environmental review team report

ARROWHEAD RIDGE
Coventry, Connecticut

ENVIRONMENTAL REVIEW TEAM REPORT
ON
ARROWHEAD RIDGE
COVENTRY, CONNECTICUT
NOVEMBER, 1975

ENVIRONMENTAL REVIEW TEAM REPORT
ON
ARROWHEAD RIDGE
COVENTRY, CONNECTICUT

TOPOGRAPHY

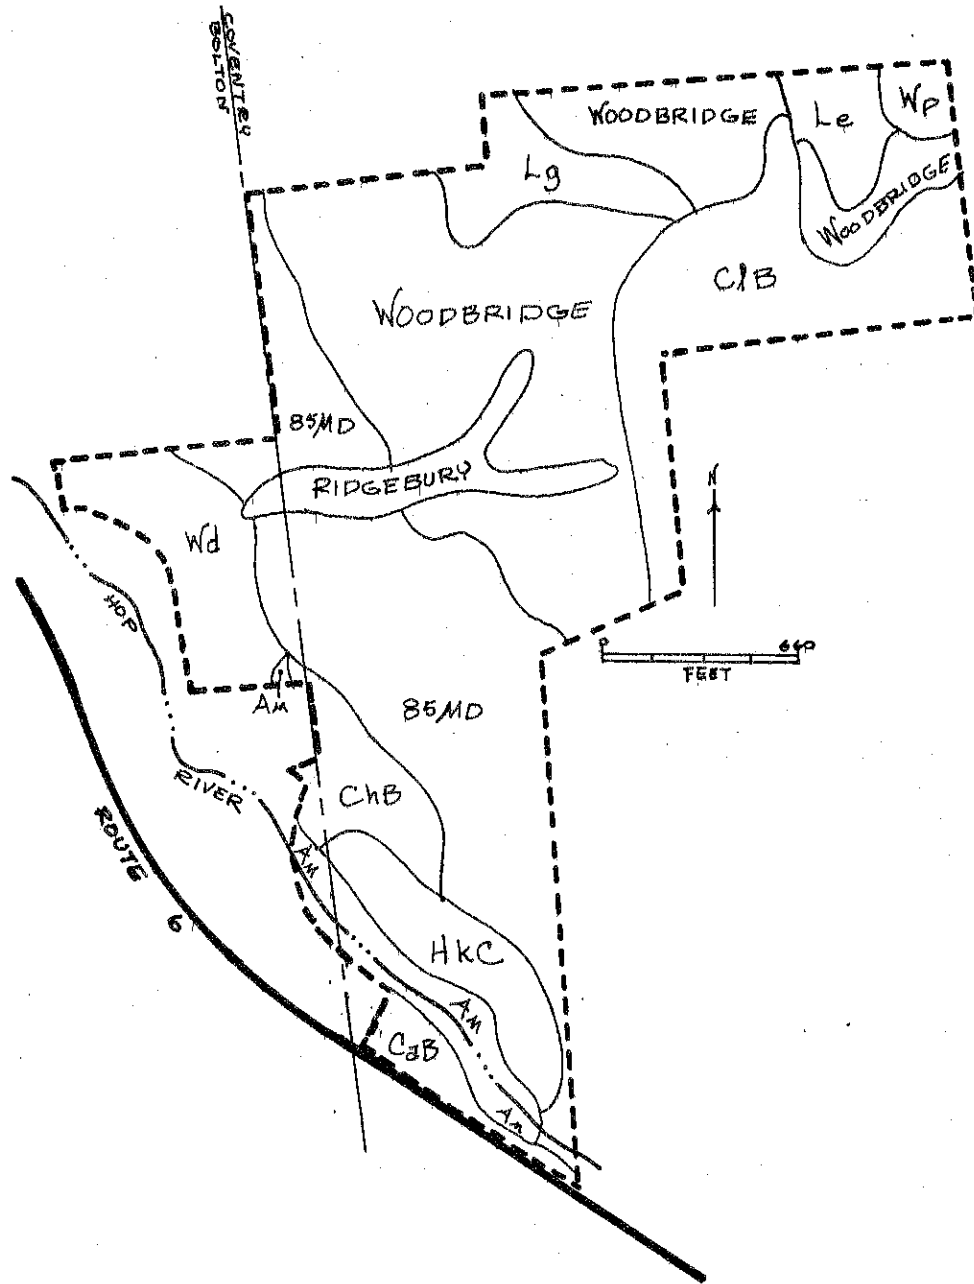
The topography map illustration indicates the approximate area of the site which falls within the 15% or greater slope regime. The development plans for Arrowhead Ridge indicate that the leaching field galleries are proposed for the same approximate area.
